**Subject: Comments of Casitas Municipal Water District on the State Water Resources Control Board (SWRCB) Development of Groundwater-Surface Water and Nitrogen Transport Models of the Ventura River Watershed (Ventura River Watershed Modeling Study)**

Review of the California State Water Resources Control Board's December 2019 *Final Study Plan for the Development of Groundwater-Surface Water and Nutrient Transport Models of the Ventura River Watershed*, prepared by GSI Water Solutions, One-Water Hydrologic, and IRP Water Resources Consulting, dated July 2021

**Review of the California State Water Resources Control Board's December 2019  
*Final Study Plan for the Development of Groundwater-Surface Water and Nutrient Transport Models of the Ventura River Watershed***

**Figure 2-1. Existing Ojai Valley Basin Groundwater Model Grid Extent of Active Model Cells (OBGM), Bulletin 118 Groundwater Basin, and Watershed Extent (Geosyntec and DBS&A, 2019, Figure 2-1)**

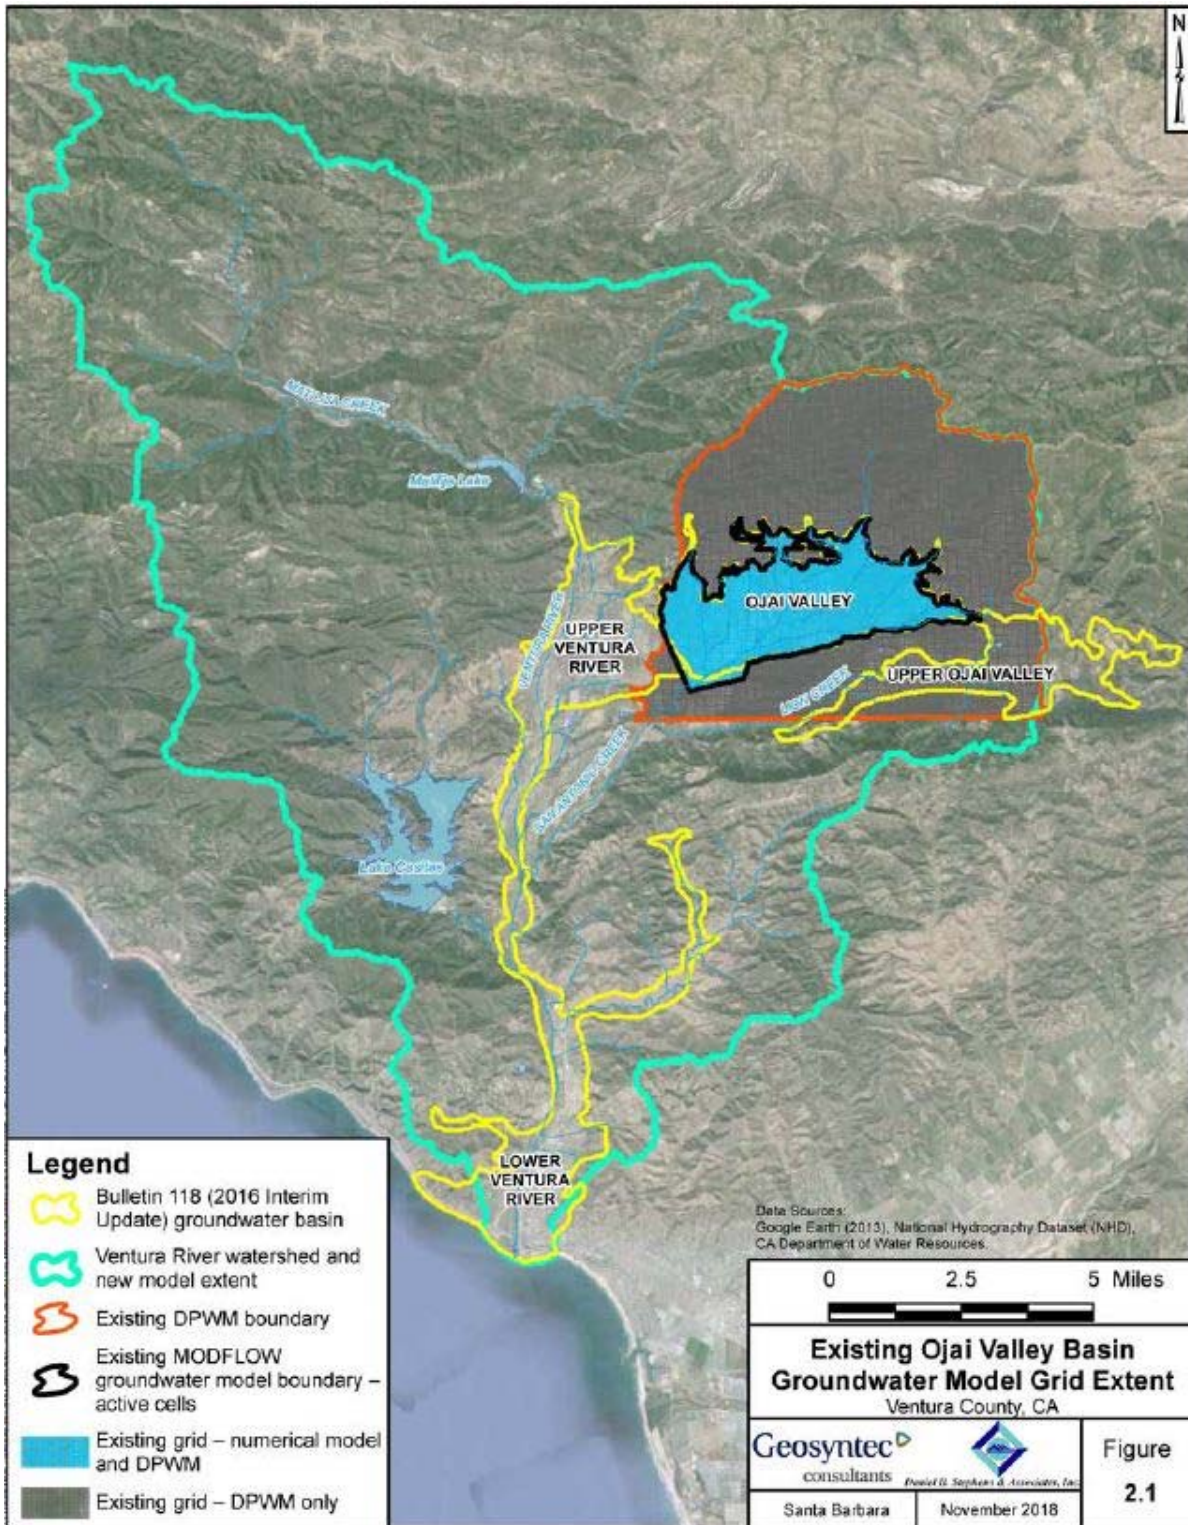
Two flow models of parts of the Ventura River Watershed were summarized in this section of the Plan as the Ojai Valley Basin Groundwater Model (OBGM) and Ventura Surface Water Hydrology Model (VSWHM) (see Figure 2-1 below) (Geosyntec and DBS&A, 2019, Figure 2-1). This applied model uses the proprietary version of MODFLOW called MODFLOW-SURFACT (developed by HydroGeoLogic Inc.

The OBGGM model includes 10 layers of variable thickness with 109 rows and 190 columns of square (equal-dimensioned cells) of 200 feet by 200 feet simulating 175 seasonal (3-month) stress periods. Time stepping through these seasonal stress periods is amplified by a factor of 1.2 resulting in time steps ranging from less than a day up to 10 days in length. The model was run in MODFLOW-SURFACT (MS, version 3) and in Groundwater Vistas (GWV) using the Basic (BAS) Package to define the active extent and initial groundwater levels for all cells within each model layer, Block-Centered Flow (BCF) Aquifer Package, the Drain (DRN) Package, the Evapotranspiration (EVT) Package, the General-Head Boundary (GHB) Package, the Recharge Seepage Face (RSF4) Package, the Single-Aquifer Well (WEL) Package and the Fractured-Well Package (in MODFLOW-SURFACT only), the Output Control (OC) Package renamed as the ATO (Adaptive Time Output) Package in MODFLOW-SURFACT, and the Preconditioned Conjugate Gradient (PCG) Solver Package. The upper most parts of all 10 layers are potentially convertible from confined to unconfined storage properties from within the UGSS BCF flow package that was also used to delineate the primary and secondary storage, horizontal hydraulic conductivity, vertical leakance, and top of each of the 10 model layers. The output included the MODFLOW-style list file, and an error file, as well as cell-by-cell flows and cell-by-cell recharge, heads, and drawdowns.

**Figure 4-1. Cumulative Departure of Annual and Seasonal Precipitation from Kingston Reservoir, Ventura, Station 122, 1935–2019 (PDO: Pacific Decadal Oscillation climate index)**

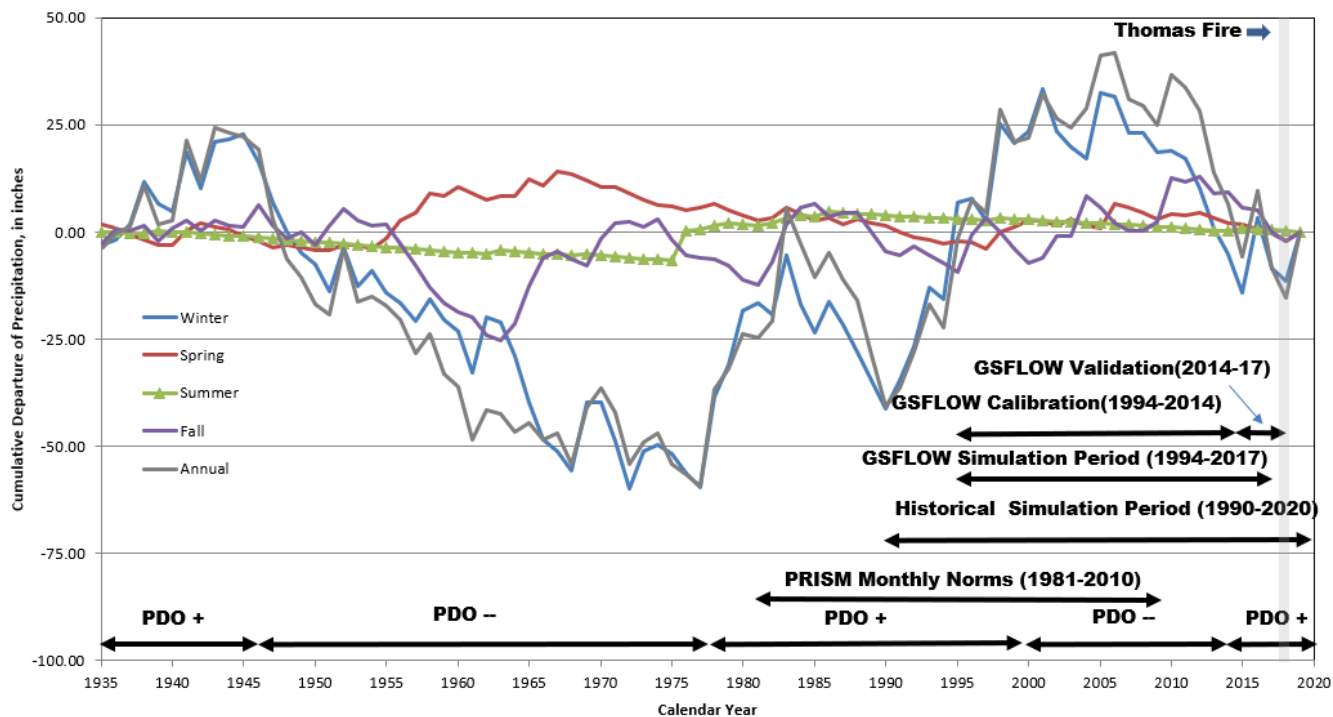
migration season of January–June, 62 percent of the winters and 65 percent of the spring seasons are dry. This suggests that dry-year and dry-season climate will largely influence the fit of any watershed models.

The regional estimates developed within PRMS from the climate stations (Figure 4-1 in the Study Plan) that are proposed as used for the PRMS model for the period 1990–2020 should be checked against PRISM estimates of precipitation and BCM estimates of Potential Evapotranspiration (PET) and Actual ET. The cumulative departure curve (Figure 4-1) for the period 1990–2019 represents 14 wet years and 16 dry years. However, this interval is a predominantly wet period (1990–2005) followed by a predominantly dry period (2006–2019). In addition, the period from 1981–2010 shows parts of two other composite climate cycles with 13 wet years and 17 dry years (Figure 4-1) are part of two other composite climate cycles.

**Figure 4-2. Example of Digital Elevation Model Correction Issues (Meadows and Wilson, 2021)**

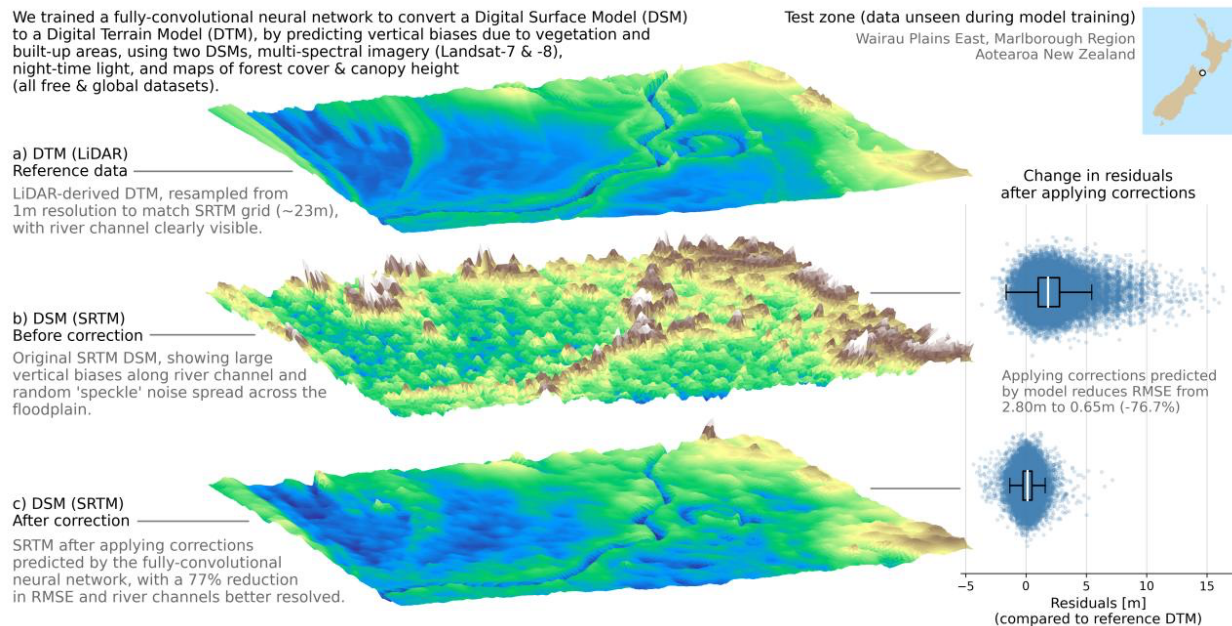
Based on the quality assurance/quality control (QA/QC) report, the 2005 LiDAR survey has a range of accuracy as required by FEMA of between 0.965 and 0.798 feet, based on 20- and 60-point comparisons, respectively (RBF Consulting, 2009). Similarly, the total accuracy (RMSE) from low, medium, and high vegetations heights was summarized at 0.731 feet. As has been shown in other recent studies (e.g., Hanson et al., 2020), digital terrain data as DEM or LiDAR can include some errors that may need resolution, especially in the flat areas of a watershed. The most common approach is to use surveyed land-surface elevations from benchmarks, stream gages, highways, and wells to check and potentially adjust for errors in land-surface elevation model data. More recently, Meadows and Wilson (2021) developed a public domain correction software to help mitigate this issue for regions where only DEM data is available and LiDAR data may not be available, as shown below in Figure 4-2. Even the LiDAR data should be checked against other 1st-order and 2nd-order surveyed points, where possible, along the flatter regions of the watershed and floodplain.

**Figure 4-6. Streamflow Duration for Daily and Monthly Flows for Ventura River near Ventura**

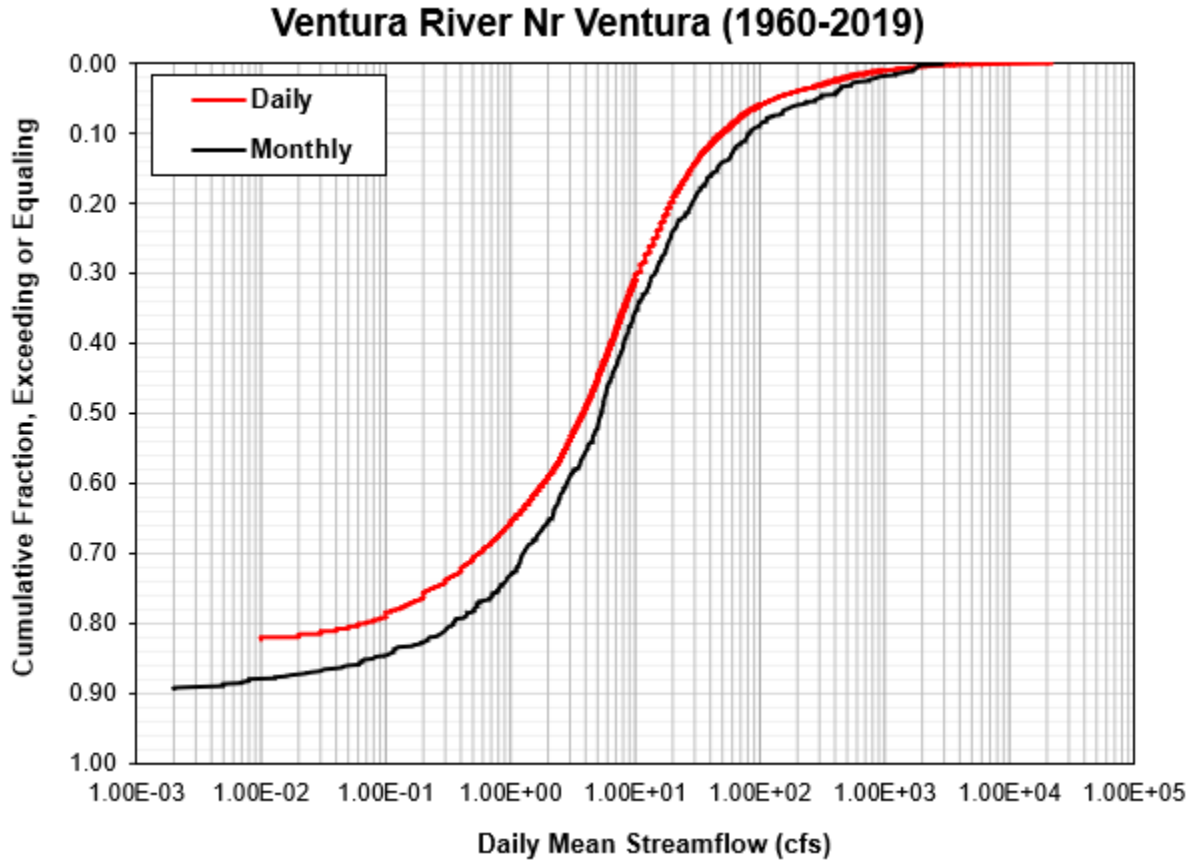
In addition, higher-order observations, such as wet-year and dry-year daily, monthly, or seasonal streamflow duration, should also be used to further estimate the skill of the calibrated model to replicate the flows at several exceedance values (see Figure 4-6 below). For example, streamflow duration for wet and dry years has a considerable difference and would need to be explicitly analyzed since the CDFW flow and stage targets for various streams are commonly segregated into wet and dry-year conditions (see Figure 4-6 below). The difference here indicates that for the median streamflow, the wet-year streamflow (17 cfs) is 6.5 times greater flow than the dry-year median streamflow (2.6 cfs), and there are only 5 years in the proposed simulation period (1990–2020) that include both a wet winter and spring. This is similar to the tributary wet and dry-year flows estimated for tributaries of the Santa Clara River draining the nearby Topatopa Mountains that ranged from five to seven times greater daily median flows for wet years (Hanson et al., 2003). As mentioned previously, the multi-year recession of minimum flows will also need to be a separate group of observations to assess skill of the model for surface-water flows for assessing nitrate transport and fish passage.

**Figure 4-7. Streamflow Duration for Wet and Dry-Year Daily Flows for Ventura River near Ventura**

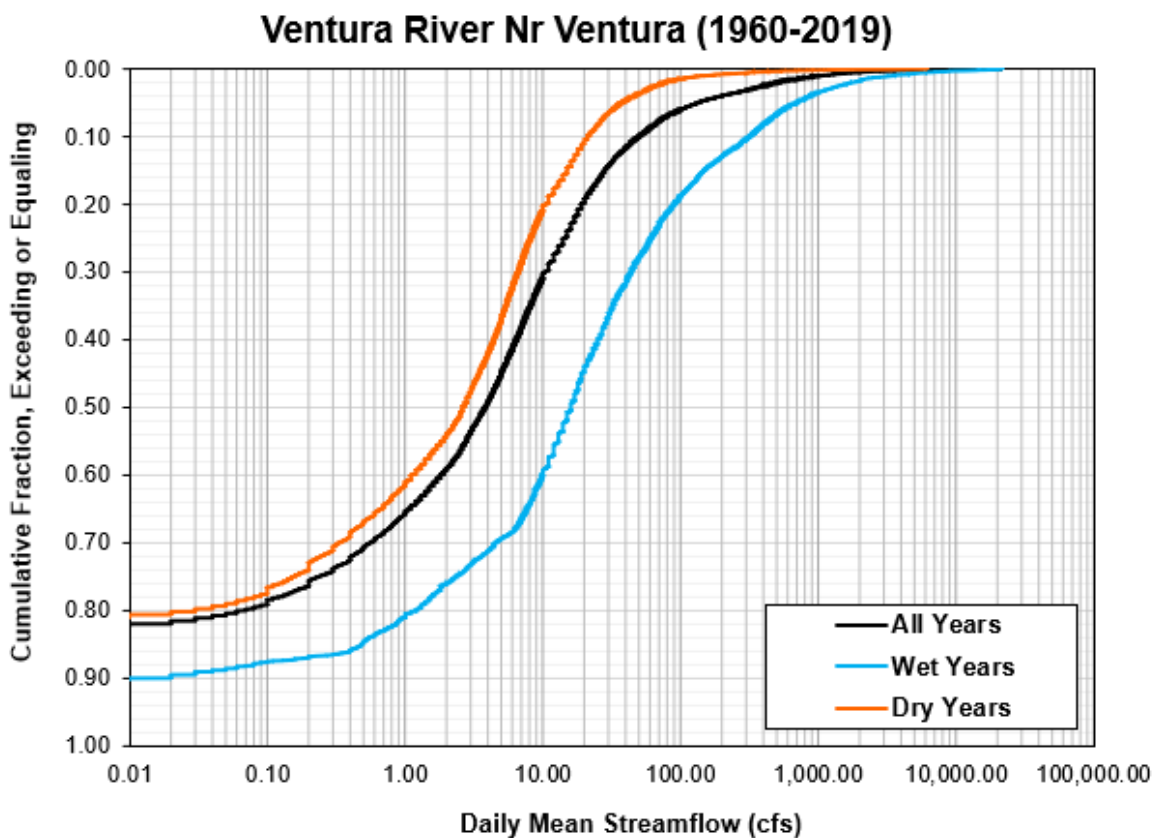
Fire. Reworking of the rating curve for Ventura River near Ventura (11118500) is also good. These weekly measurements for the period December 2017 to October 31, 2018 are posted in National Water Information System (NWIS) and most are in the Fair to Poor category. Post-Thomas Fire simulation periods may require a change in streambed morphology and streambed vertical hydraulic conductivities for this part of the historical simulation period. There are also selected abandoned wells near the stream channel and near the gage at Foster Park that could be used to assess the vertical head difference between groundwater levels and stream stage that should be included in the model calibration observations.

**Figure 6-1. Cumulative Departure of Annual and Seasonal Streamflow of the Ventura River near Ventura (USGS 11118500) 1960–2019**

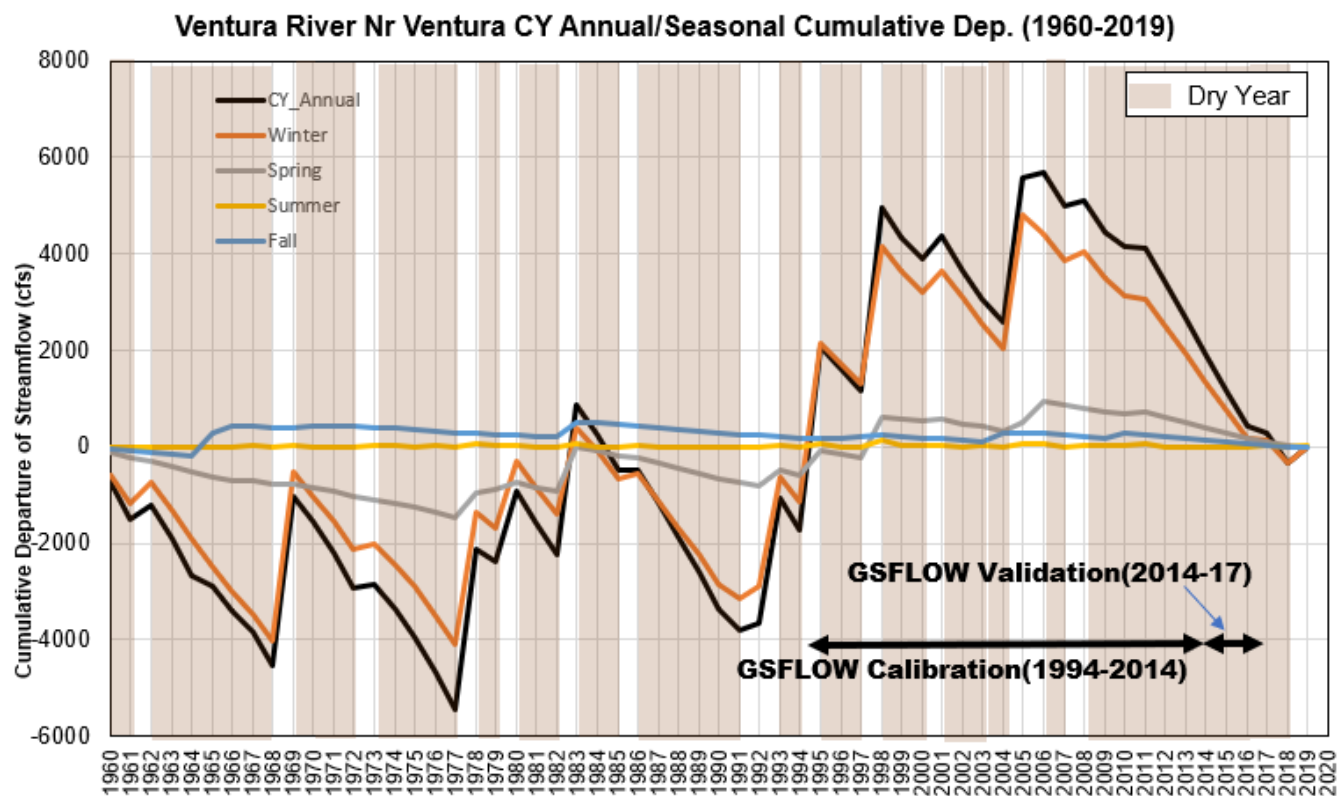
- The selected 24-year simulation period for the integrated model is not consistent with the wet and dry-year variations in streamflow cycles with 6 wet years and 18 dry years, and a multi-year recession occurring since 2006 (see Figure 6-1 of the attachment).

Related to the simulation period for the integrated model, the review notes that the selected period is not consistent with the wet and dry-year variations in streamflow cycles (see Figure 6-1 in this report) that comprise 6 wet years and 18 dry years with multi-year recession occurring since 2006.

The modeling periods delineated for the calibration (21 years) and “validation” (2 years) of the GSFLOW model occur under different climate regimes of the PDO climate cycles (see Figure 4-1 in this report). However, these periods are not consistent with the wet and dry-year variations in streamflow cycles (see Figure 6-1 below) that comprise 6 wet years and 18 dry years. Multi-year recession periods have occurred since 2006 and is likely in concert with inflows and related changes in reservoir storage and stage level at Lake Casitas. This figure is comparable to the historical time series of stage presented for Lake Casitas, suggesting that they are both responding to similar flows.

**Figure 6-2. Santa Clara Historical Climate and Surface-Water Events (Hanson et al., 2003, Figure 2B)**

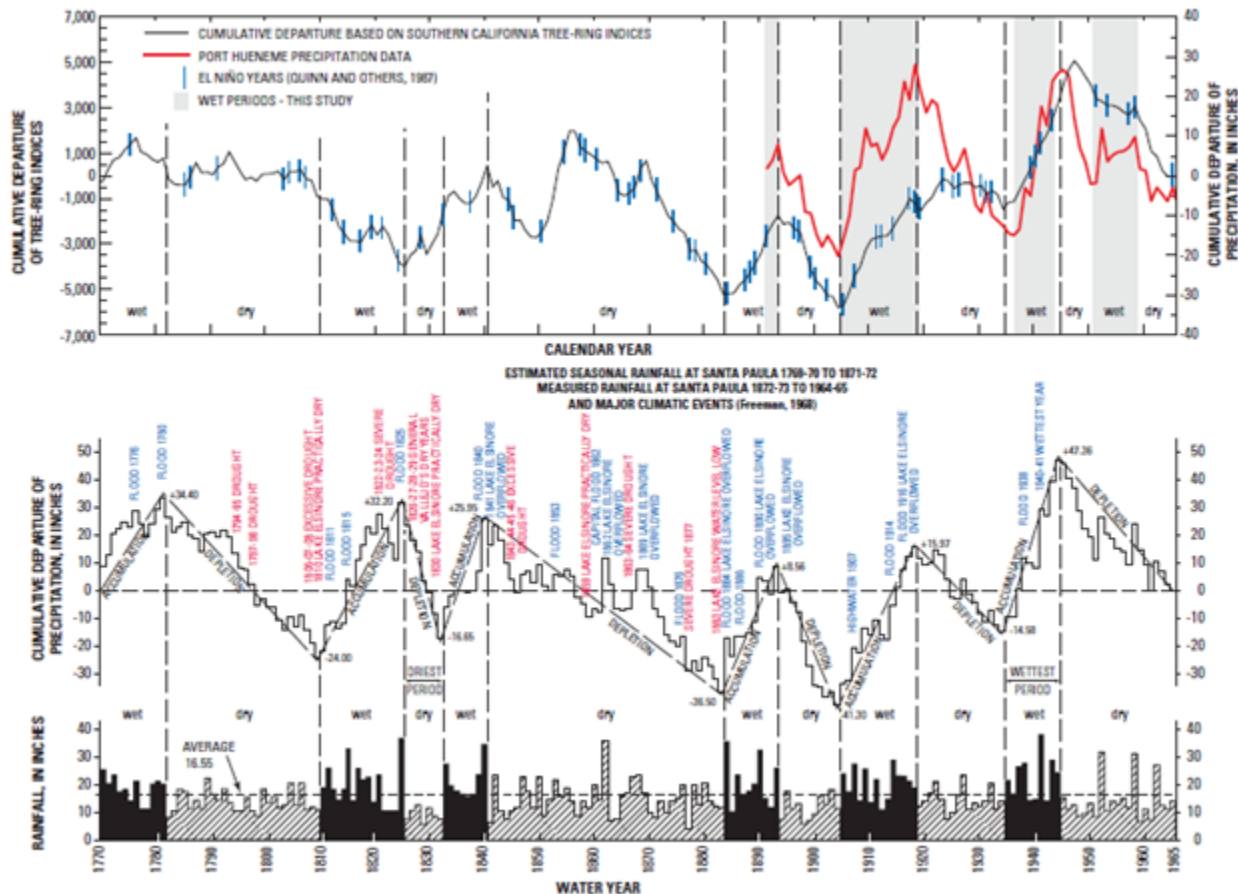
additional analysis outside of the models proposed. Some of this type of analysis was already completed by the USGS studies of the adjacent Santa Clara-Calleguas Basin study (Hanson et al., 2003; Figure 6-2 in this report) and by the more recent climate variability studies (Hanson et al., 2006). An analysis of climate variability from precipitation streamflow, and possibly tree-ring indices may be required to give a more complete and quantitative analysis to the period long enough for capturing the drought and flood years. This could easily be facilitated using the USGS HydroClimate Toolkit (Dickinson et al., 2014) for selected hydrologic time series to assess the proper periods of simulation and the climate cycles that are embedded within that period. Additionally, the other major issue for having an adequate period of simulation is the slow rate of transport of nitrates. This was a major issue for CV-SALTS in the Central Valley assessments that used the Central Valley Hydrologic Model but only had a historical period of a couple decades and that was inadequate to assess the slow transport from potential nitrate sources to points of observations, such as rivers and wells. This consideration was not identified in the Study Plan but needs to be an additional consideration for having any verification of actual transport relative to measured nitrate samples from wells or surface water sources.

shown below in Figure 6-2. While the PRMS model will use daily time steps, the example from the Lower Walker River model required running the groundwater model of GSFLOW in monthly time steps. When it was connected to the proprietary software (MODSIM) to include reservoir operations, the PRMS model had to be run in weekly time steps because of the 7-day transit-time delay between reservoir releases and downstream diversions. Therefore, the transit time for surface water flows may need to include consideration in this context if reservoir operations will be added during or after calibration.
